**MOT - 725 - 14.41**

**GENERAL NOTES**  
RETAINING WALL 3

**MOT-725-14.41**  
PID No. 108619

**GENERAL NOTES**  
RETAINING WALL 3

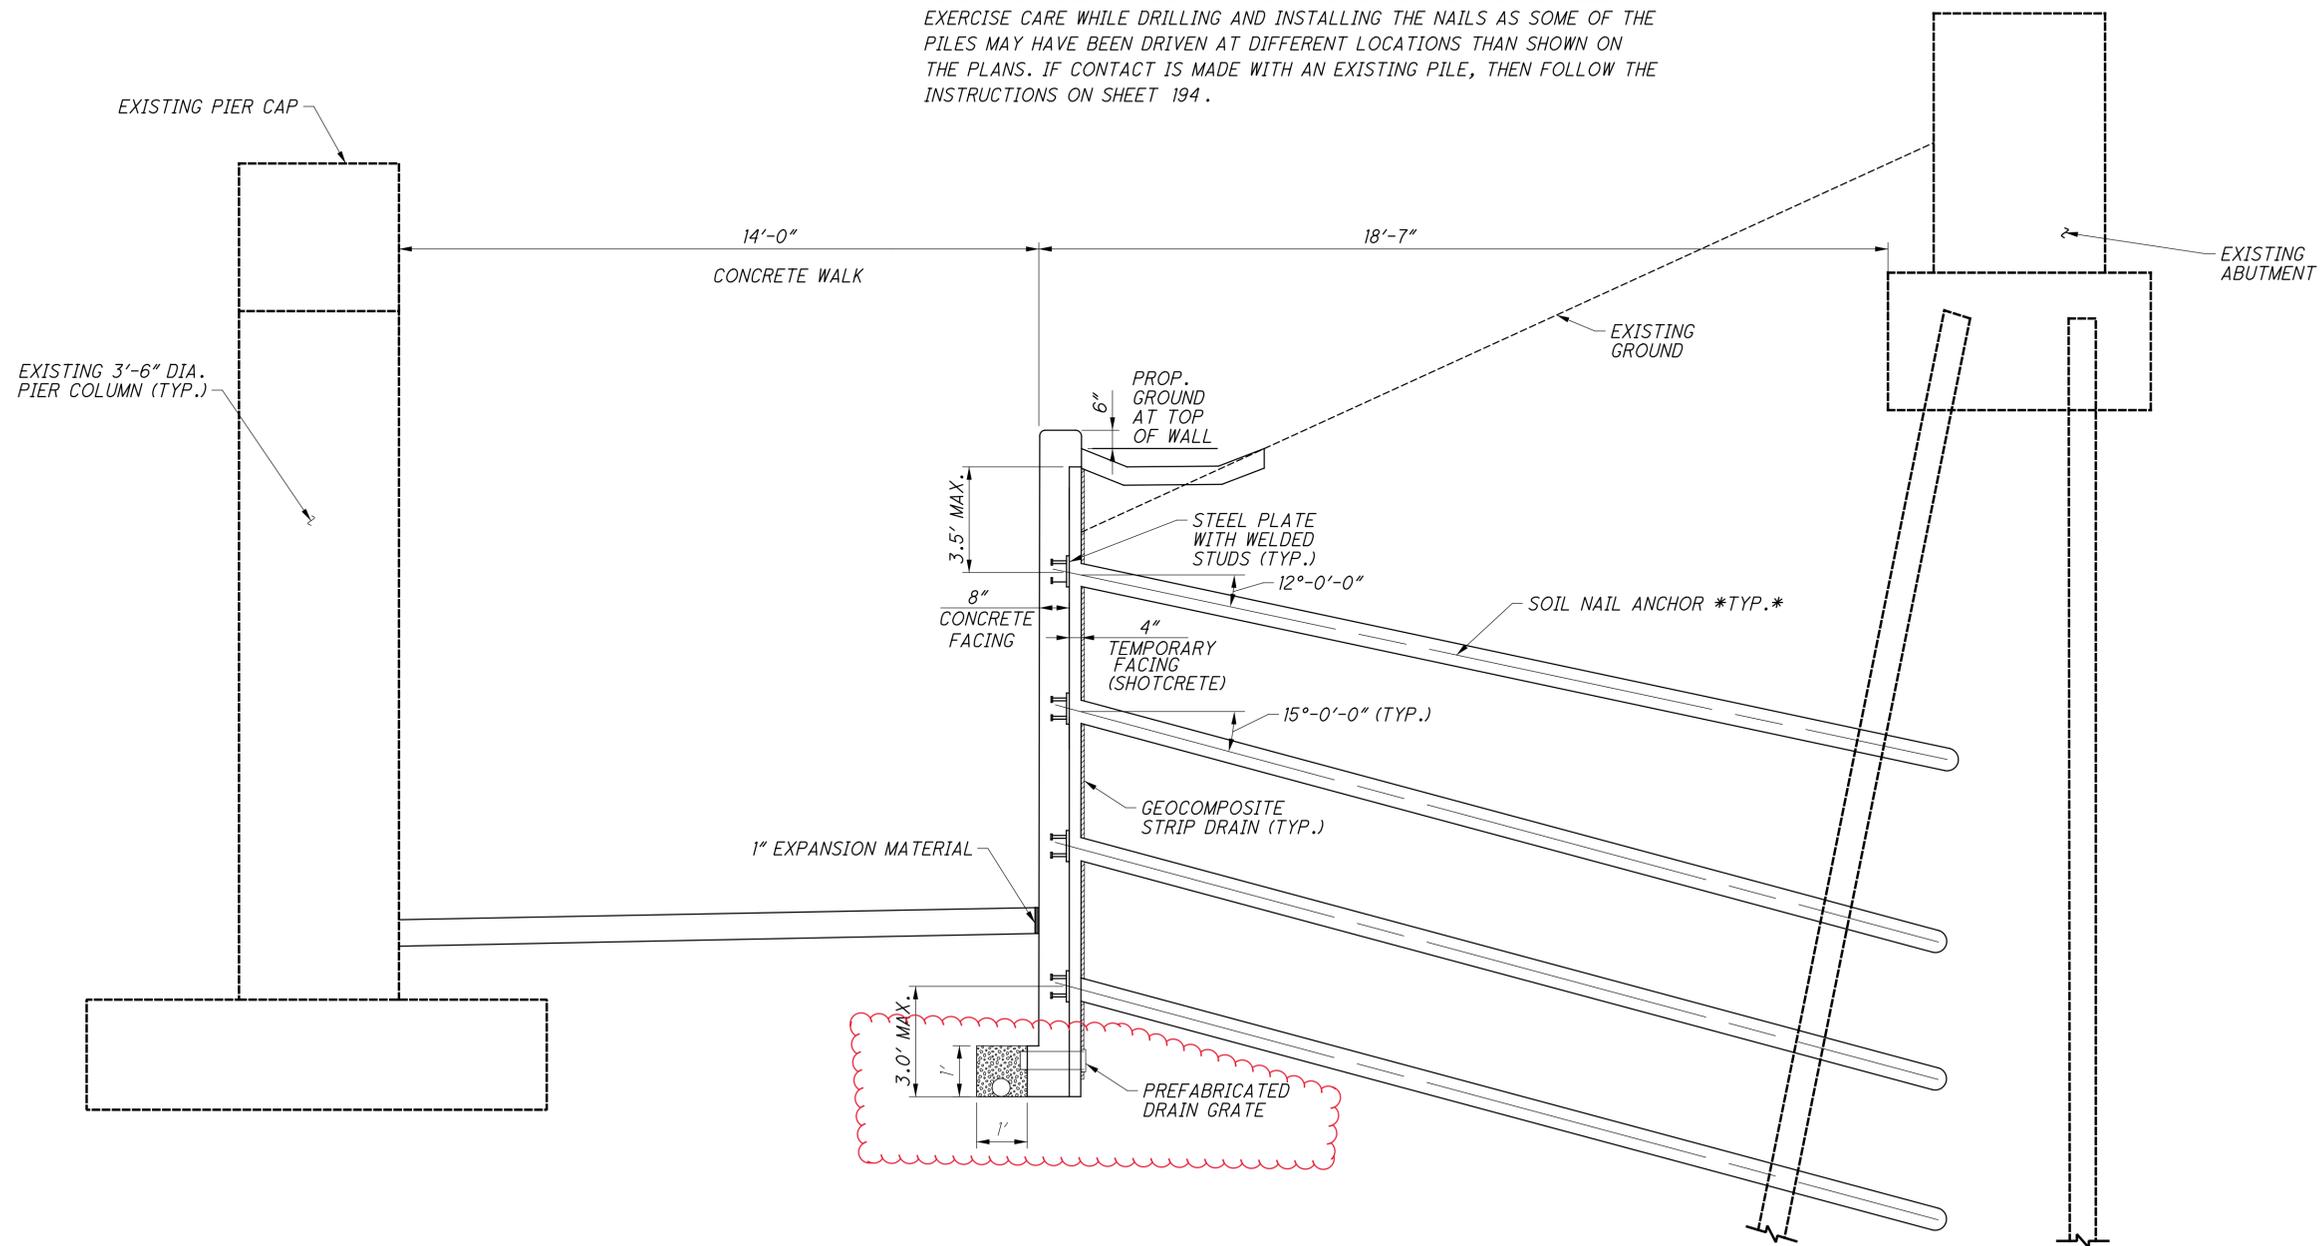
*(Handwritten note in red circles: DRAINAGE MATERIALS WILL BE PAID SEPARATELY FROM THE SHOTCRETE FACING...)*

*(Handwritten note in red circles: PNEUMATICALLY PLACED CONCRETE SHOTCRETE...)*
